**NOTICE OF ADDENDUM
ADDENDUM NO. 2**

**CONTRACT NO. 7939
MADISON MUNICIPAL BUILDING - RENOVATION**

This addendum is issued to modify, explain or correct the original Drawings, Specifications, or Contract Documents and is hereby made a part of the contract documents.

EXHIBIT E
A192

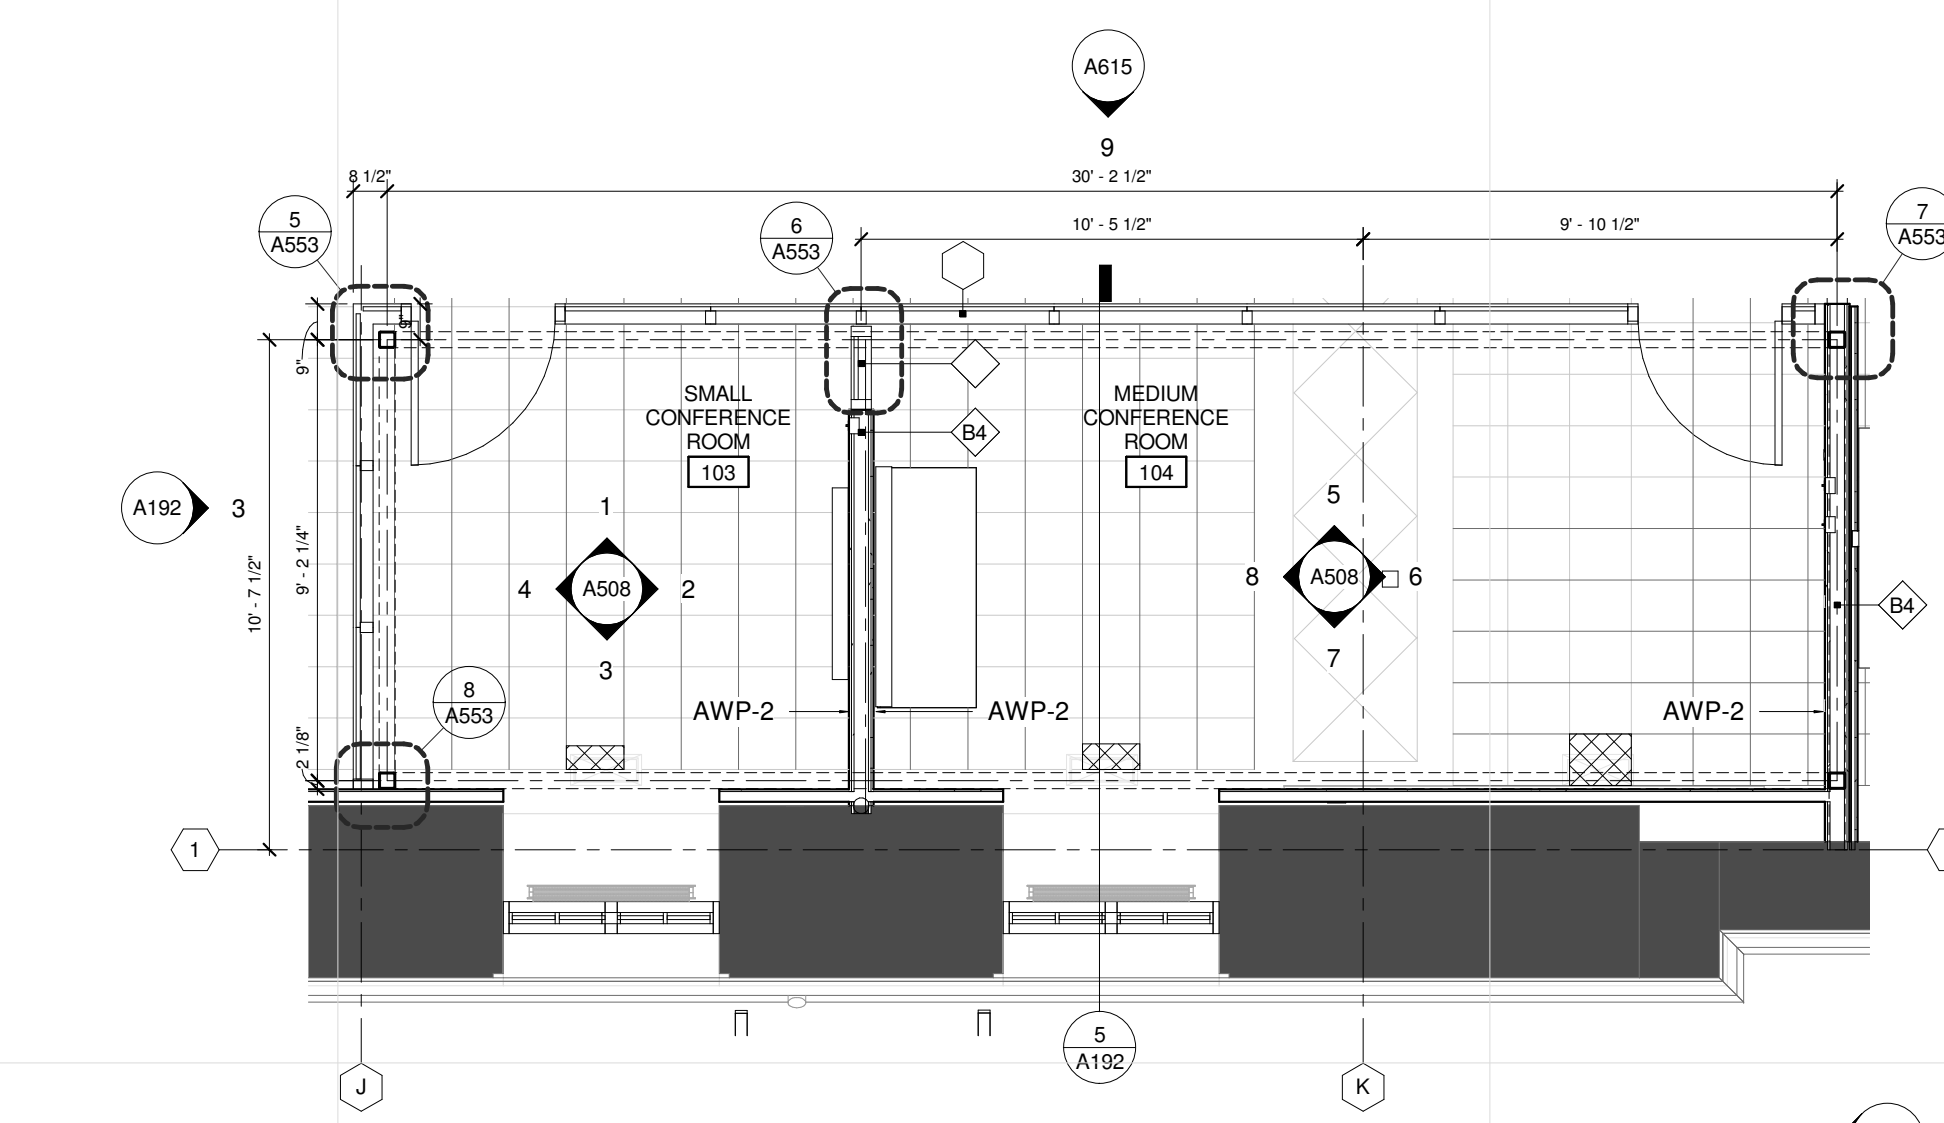
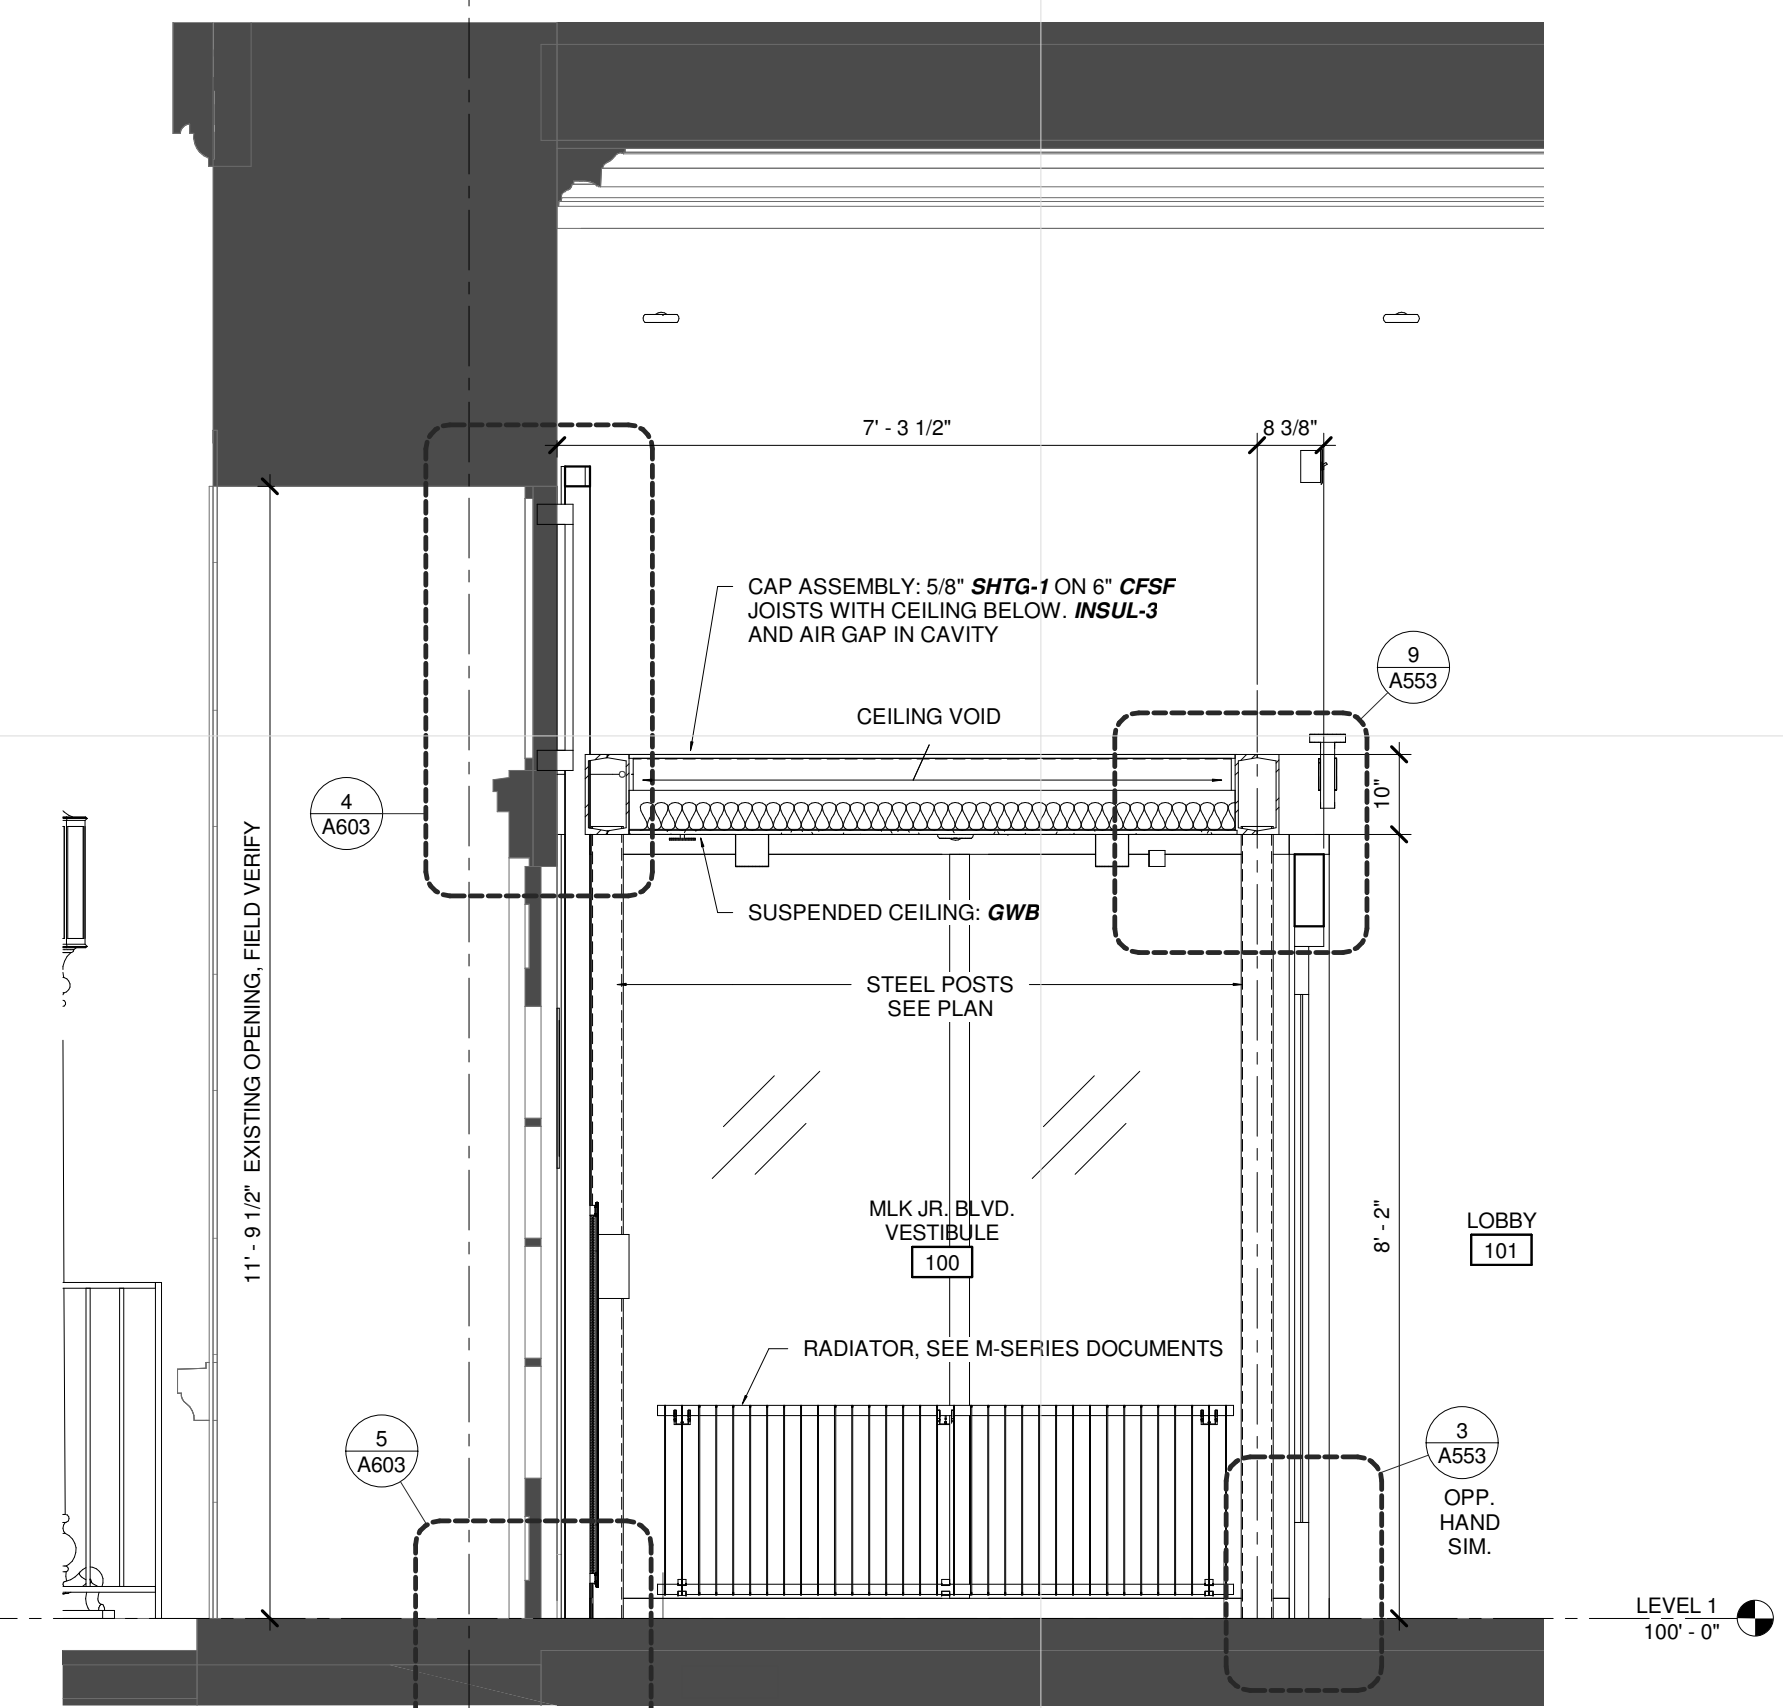
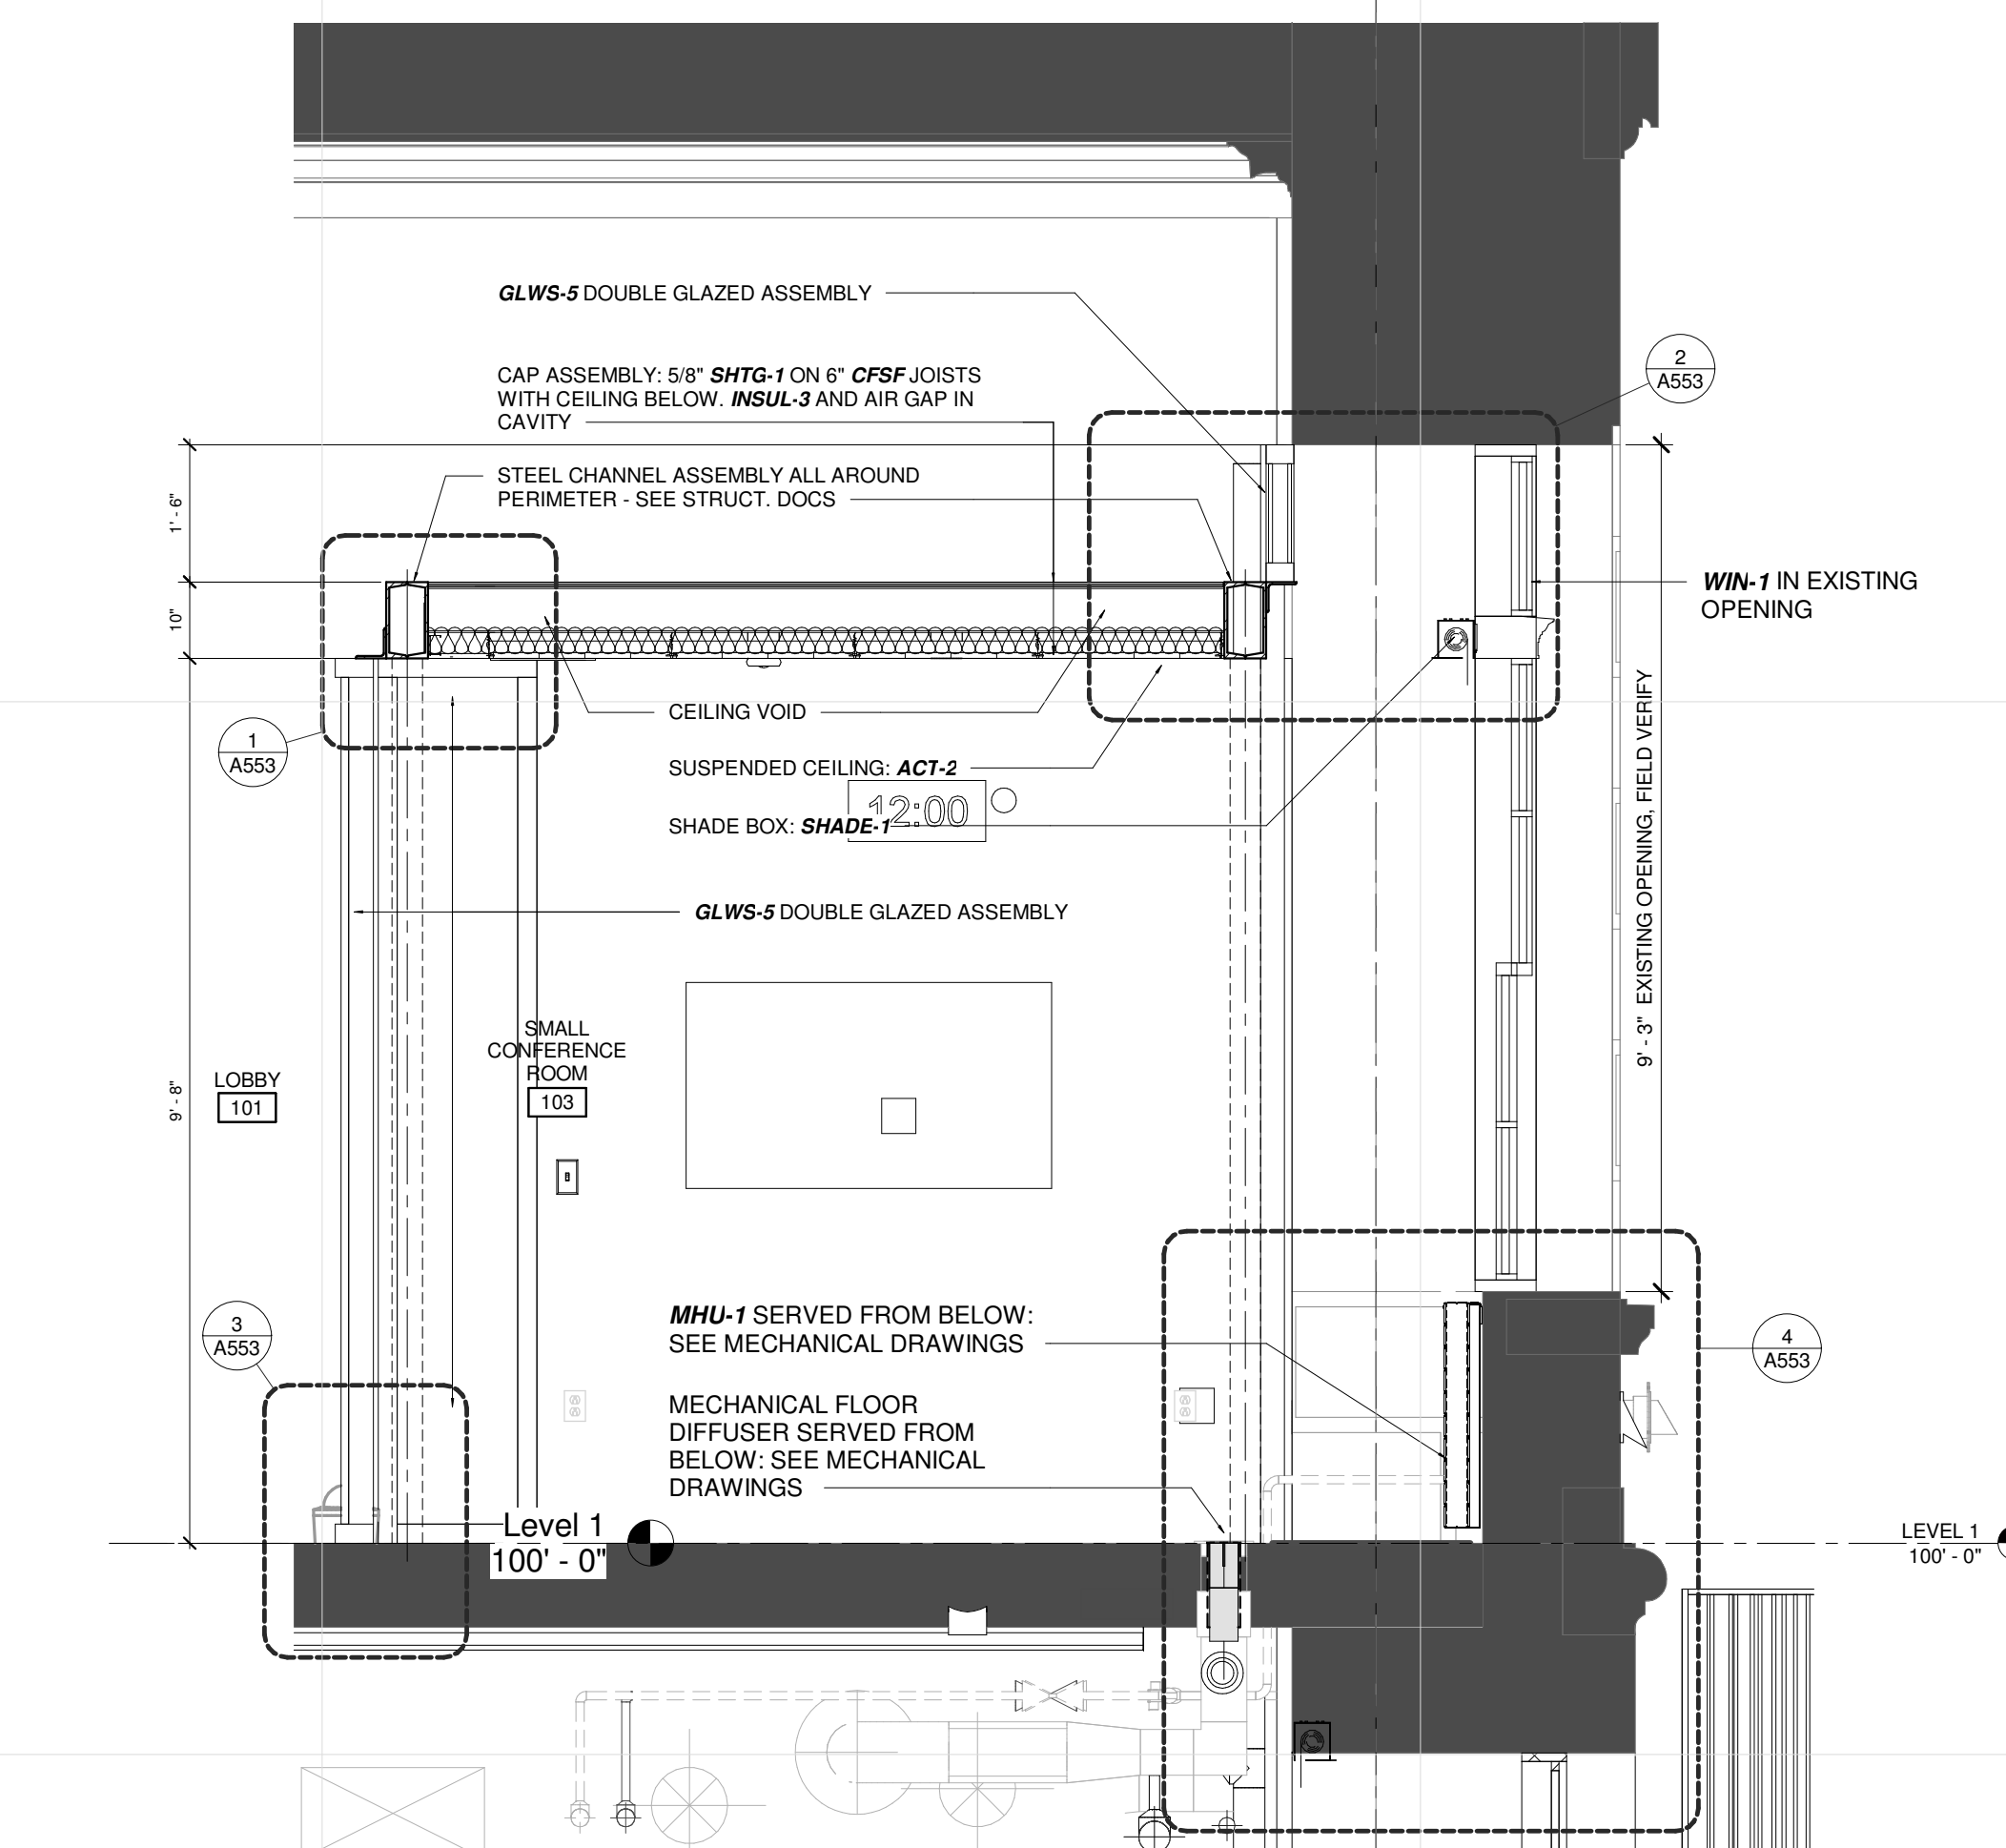
1. Detail 1/A192 Revised to center vestibule on exterior doors.
2. Details 7 and 8/A301. Revised details to clarify waterproofing notes.
3. Details 5,7 and 9/A353. Revised details to clarify waterproofing notes.
